**RE: Response to Comments
Supplemental Site Investigation Report
Former Gorham Manufacturing Site
333 Adelaide Avenue
Providence, Rhode Island**

**Supplemental Site Investigation Report
Former Gorham Manufacturing Site
333 Adelaide Avenue
Providence, Rhode Island
July 2006**

**Comments Provided By: Rhode Island Department of Environmental Protection
Case No. 2005-059 (Associated with Case No. 97-030)
Dated December 1, 2006**

ATTACHMENT A

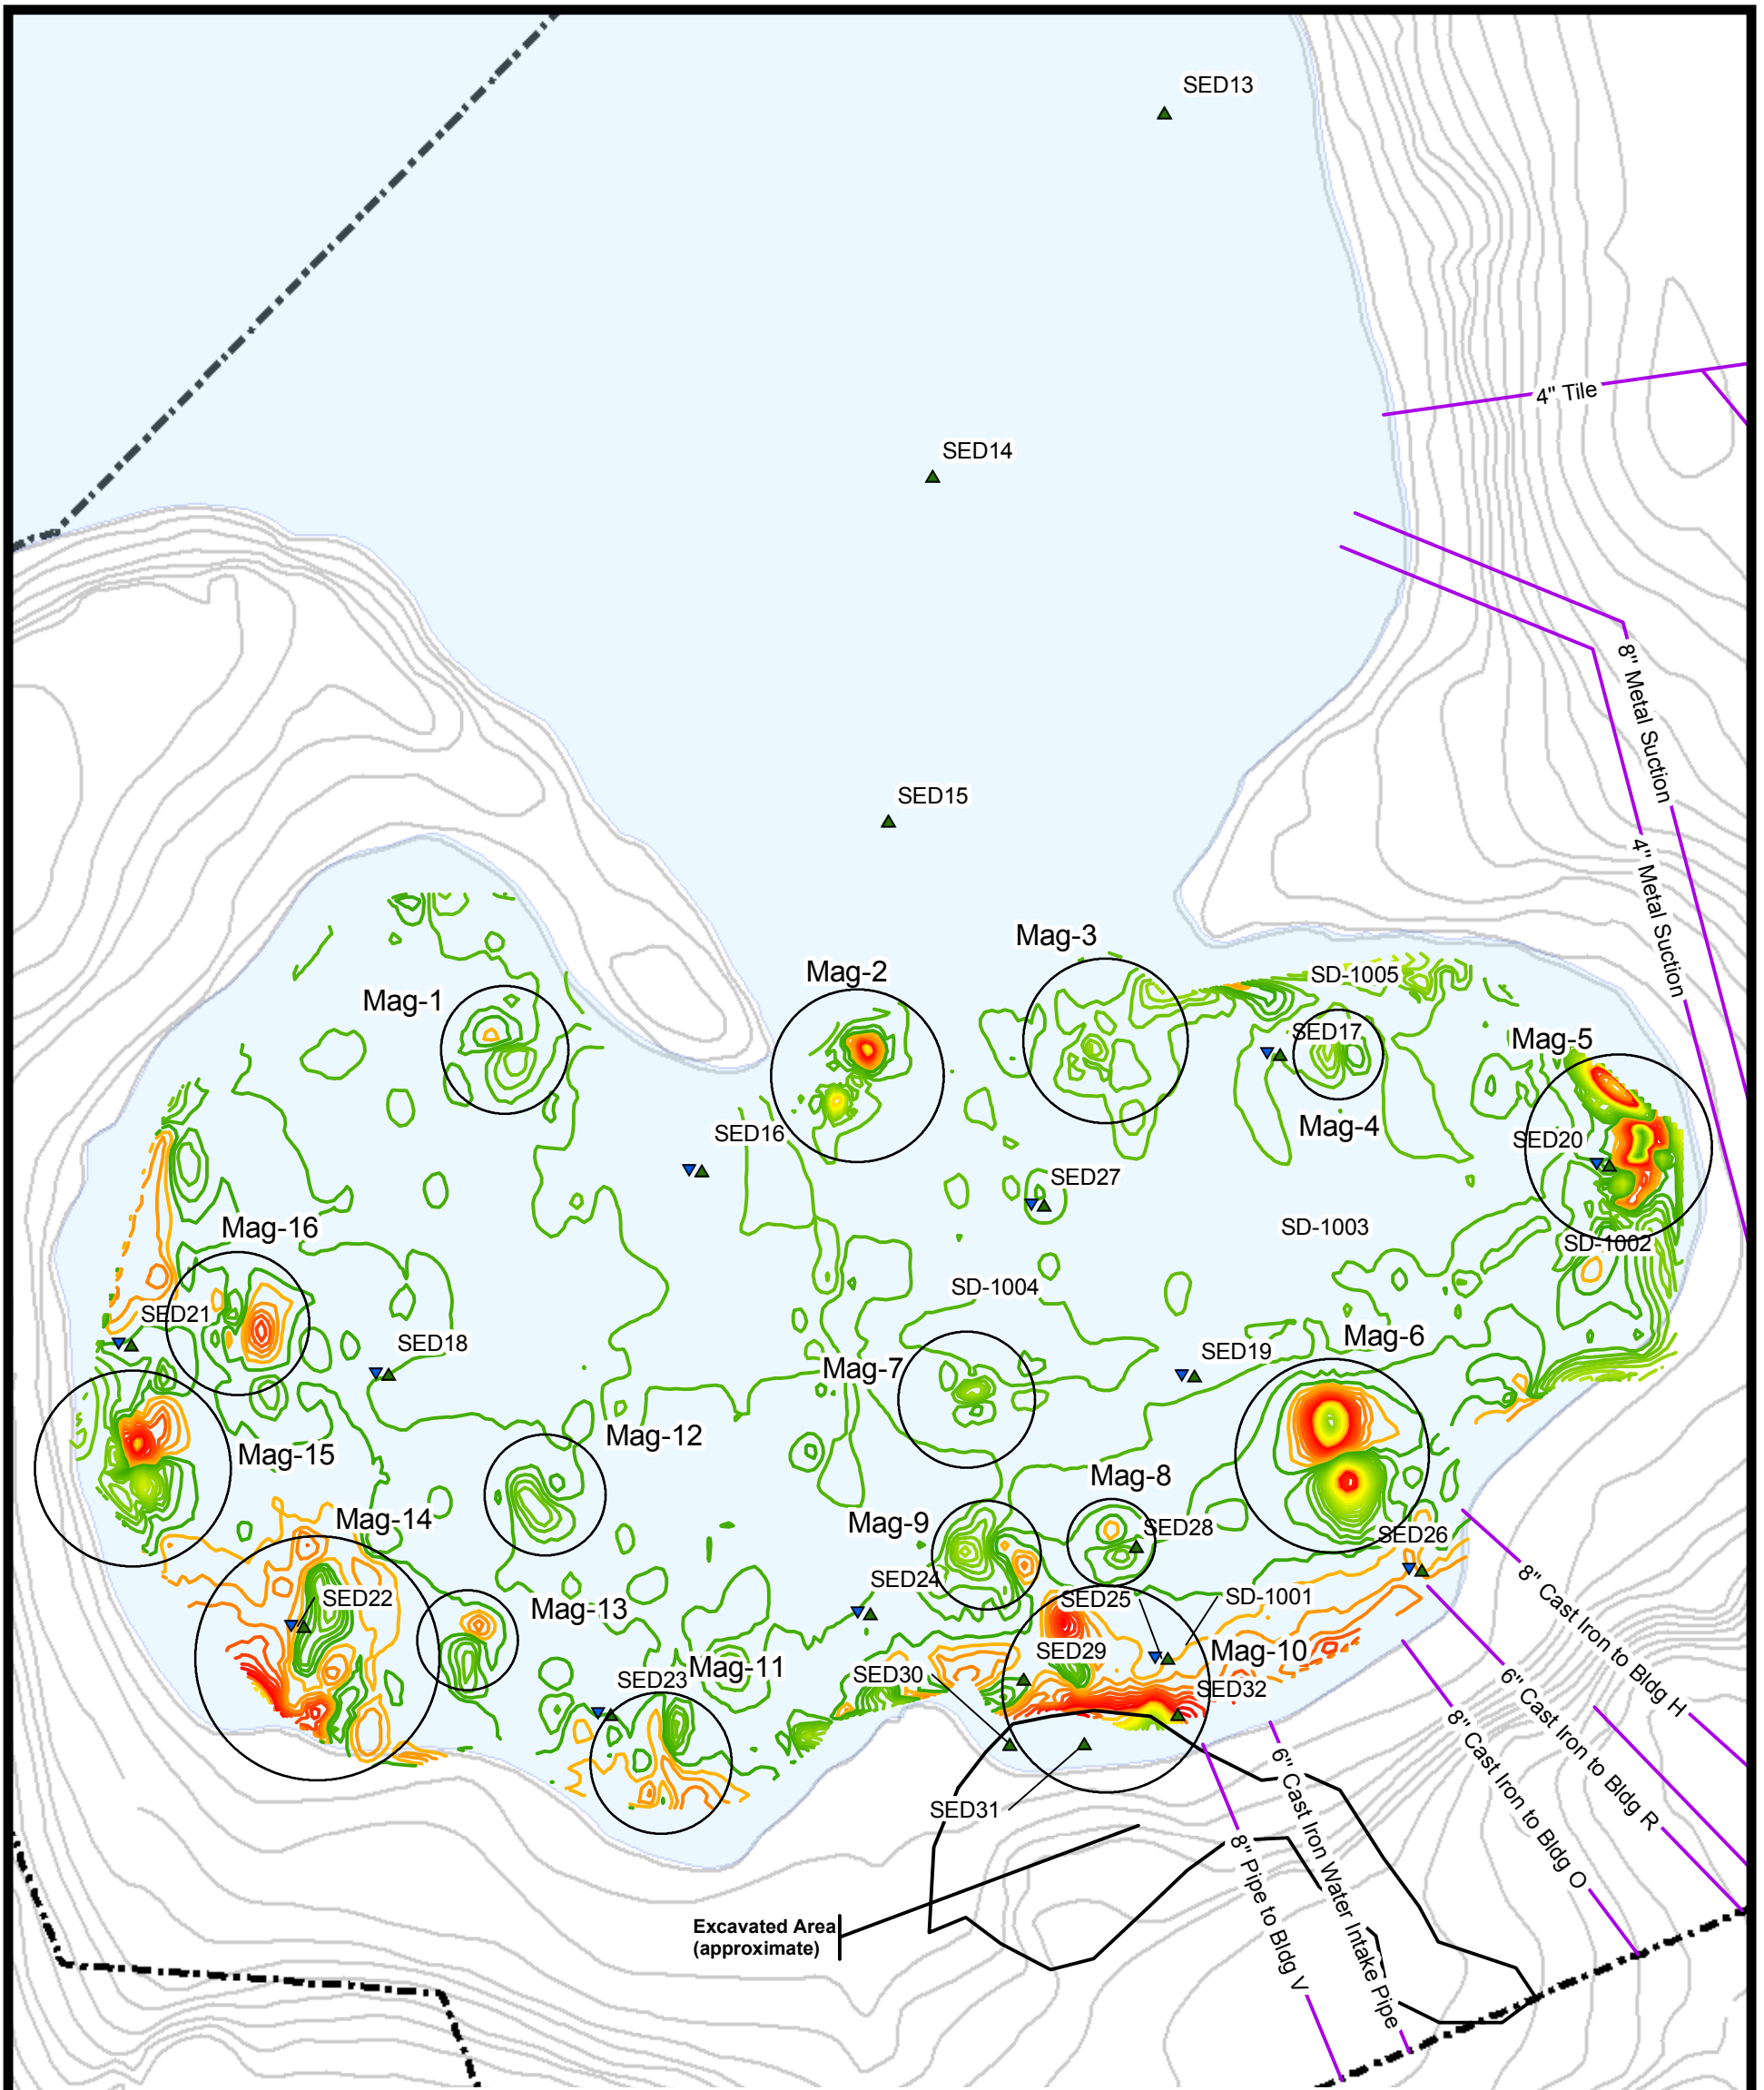
Comment 2) In our March 14, 2006 comment letter on Mactec's November 2005 draft Supplemental Site Investigation Work Plan to Support Human Health and Ecological Risk Assessment Activities – Park Parcel/Mashapaug Cove (SSIWP), the Department requested a site figure depicting measured fill depths throughout the Park Parcel (Comment 3). As this SIR is intended to address all of the Department's comments on the SSIWP, please include the requested figure in the response to this comment letter.

Comment 4) SSIR Section 3.1 (Soil Sampling), page 3-3, paragraph 1, states, "Samples collected from the upland area of the debris pile and from the adjacent sampling grid generally appeared to be fill soils which contained varying amounts of construction debris. Hand excavations indicated that a thin layer of fill (generally one to two feet) likely overlies the original native sandy soil in this area of the Site. "Did the hand excavations conclusively determine the depth of fill (i.e., always reach native soils), and does the fill cover the entire upland area?"

Response: *A figure has been prepared that summarizes the available measured fill thickness information for the Park Parcel. The figure is presented in Attachment A. The figure is based on all available field data sheets, boring logs, test pit logs, and monitoring well installation logs.*

Response: *The hand excavations did not conclusively determine the thickness of fill. However, previous investigations did provide information concerning the depths at which native soils were encountered. See Figure 1 for fill thickness information.*
